<b>Docket Number:</b>	15-AFC-01
<b>Project Title:</b>	Puente Power Project
<b>TN #:</b>	216792
<b>Document Title:</b>	Presentation City of Oxnard Past Efforts to Communicate Model Complexities
<b>Description:</b>	March 28, 2017 Workshop
<b>Filer:</b>	PATRICIA LARKIN
<b>Organization:</b>	SHUTE, MIHALY & WEINBERGER LLP
<b>Submitter Role:</b>	Intervenor Representative
<b>Submission Date:</b>	4/4/2017 10:06:15 AM
<b>Docketed Date:</b>	4/4/2017

# Past efforts to communicate model complexities

# City of Oxnard Perspective

SOIL & WATER RESOURCES - FIGURE 15  
Puente Power Project - Inundation, 100-year TWL Event, 100 cm SLR

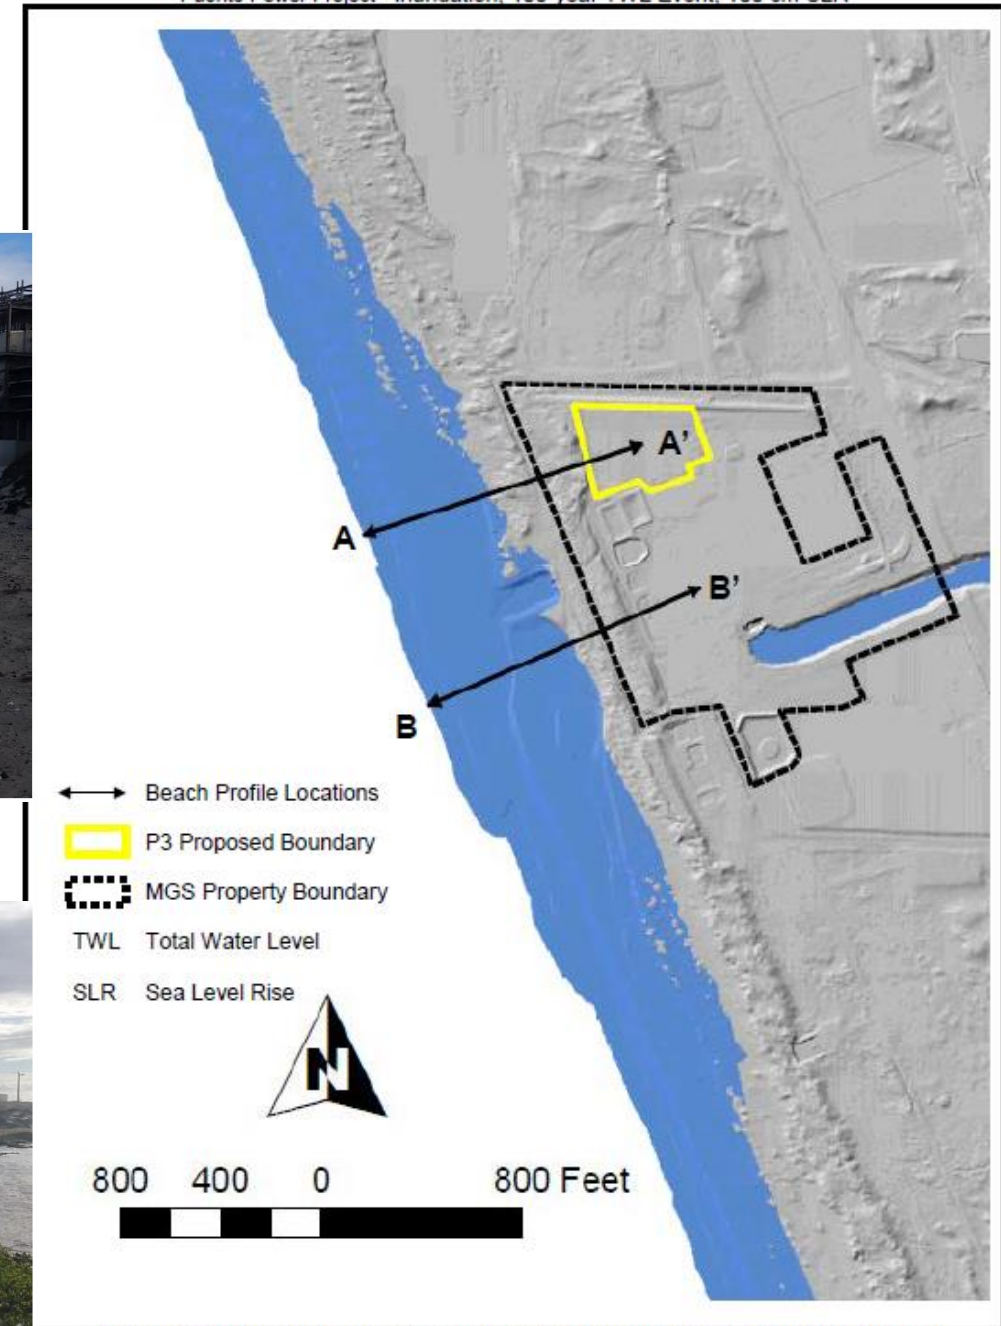
- To evaluate existing hazards, the FSA relied on the PRELIMINARY FEMA maps without discussing the specific methods or calculations used in the analyses.

- To evaluate future hazards, the FSA relied solely on PRELIMINARY COSMOS data without technical documentation. Basis was that it modeled SLR and storm events

# Preliminary COSMOS map 100 year Event & 1m of SLR

Spatial and Temporal Variations in Oceanographic and Meteorologic Forcing Along the Central California Coast, 1980–2002

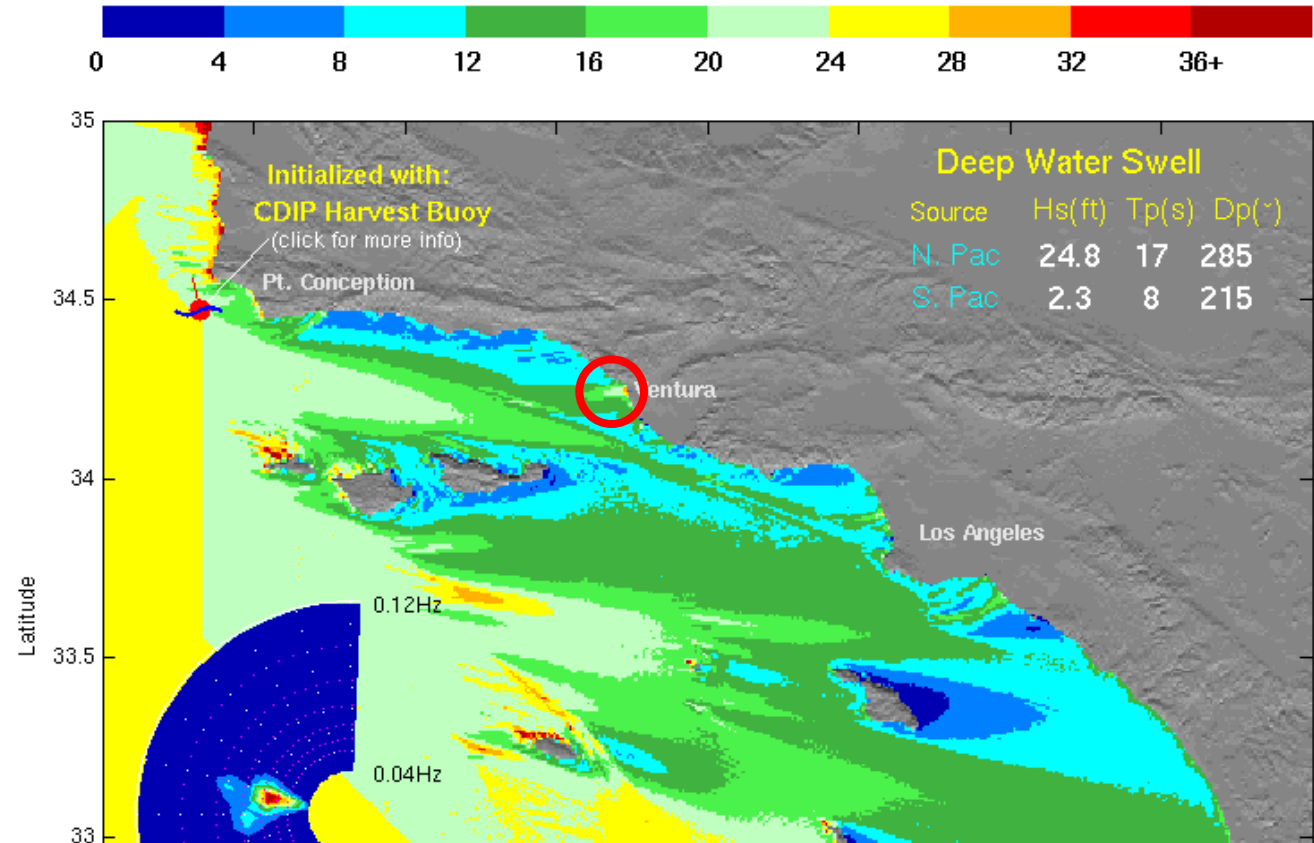
- USGS 2005 analysis of buoy records for offshore Central CA within Tier 1 wave grid
- 100 year offshore wave
- 38.3 feet (11.7m)
- 2 year offshore wave
- 25 feet (7.6m)

*Note that this represents different buoy locations, but wave direction affecting Mandalay must come through the Santa Barbara Channel. Unclear on Final Ventura methods in COSMOS*

Illustration of method used to determine the flood extent at XBeach cross-shore profile models.

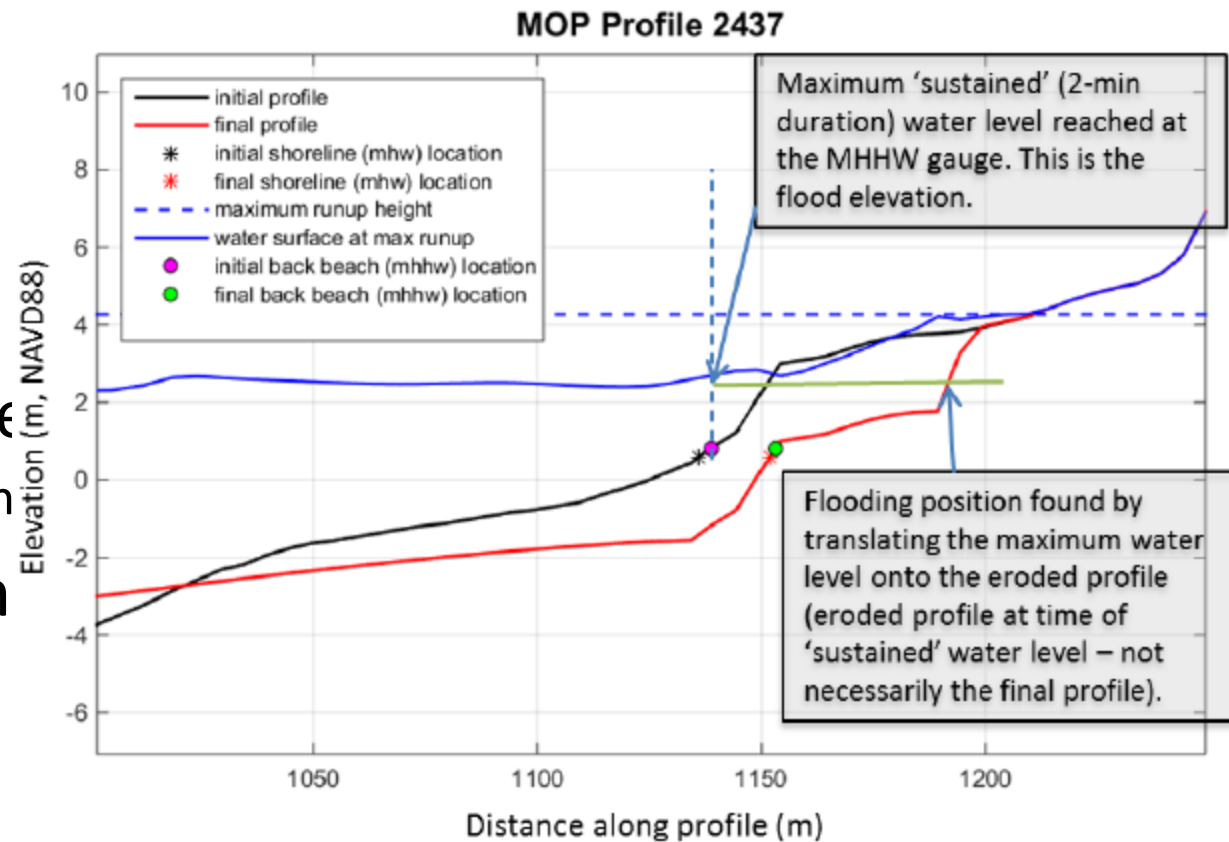
- No long term dune erosion from sea level rise
  - (only storm erosion from a single 100 year event)
- Coastal flooding and shoreline evolution (COAST) not integrated
- COSMOS Coast assumes 1995 to 2011 training period is sufficient (accretion at site = 1.1681m = 3.8325 feet/year)
- Coastal flooding defined as 2min inundation duration NOT max run up as per FEMA guidelines.

Difference in 2 minute inundation elevation versus maximum wave run up elevation in this example is ~6.6feet (~2m). A wave running up the beach 6 feet deep is capable of causing damage
